#	COMMENT PROVIDER	COMMENT	RESPONSE
1	Jerome Maa, Virginia Institute of Marine Science (October 20, 2007)	<p><i>Question 1: In your assessment, do the modeling results adequately estimate the relatively contribution from vehicle brake pad wear debris to copper levels in the San Francisco Bay? What improvements, if any, do you recommend for the presentation of results?</i></p> <p>It appears to me that the total amount of copper generated from the brake pad wear debris can be estimated from the total number of cars and trucks registered in local governments that are associated with each watershed and the average wearing rate. Of course, some of the debris may never come to the San Francisco Bay, but in general, the majority of the debris will come to the bay sooner or later. With this information, the relatively contribution from brake pad wear debris can be further confirmed. For example, if URS found that 90% of the debris generated comes to the bay, then the relative contribution would be more convincing. This information should be relatively easy to obtain and very useful.</p>	Comment noted. The work described by the commentor is a watershed modeling issue and not within URS's sc

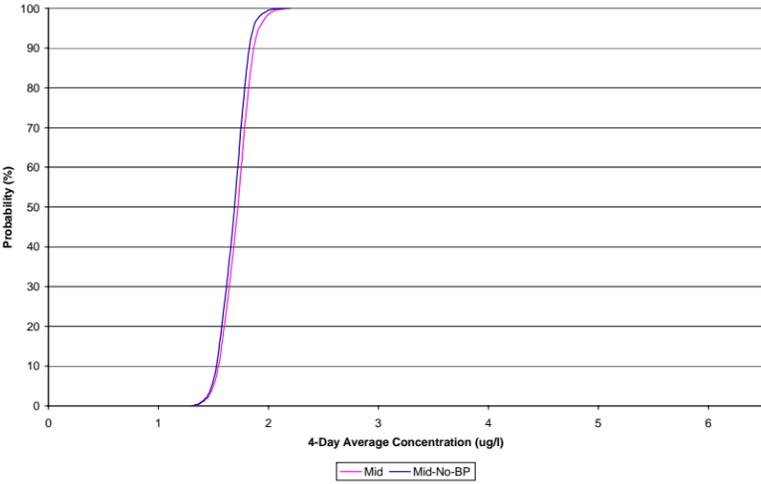
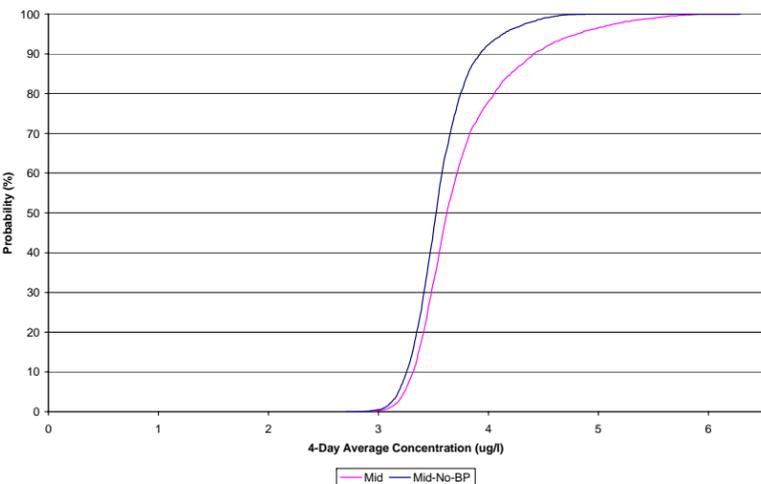
#	COMMENT PROVIDER	COMMENT	RESPONSE
19	Kelly Moran, TDC Environmental (November 9, 2007)	Figure 20. It would be easier to follow this series of figures if the same X-axis scale were used throughout.	<p>We will revise Figure 20 as requested by the commentator. Examples of the revised plots are shown below. The minimum and maximum concentrations that were shown on the existing plots will be moved to the new table created in response to comment #13 from Kelly Moran.</p> <div style="text-align: center;"> <p>(e) Oyster Point</p>  </div> <div style="text-align: center;"> <p>(j) South Bay</p>  </div>
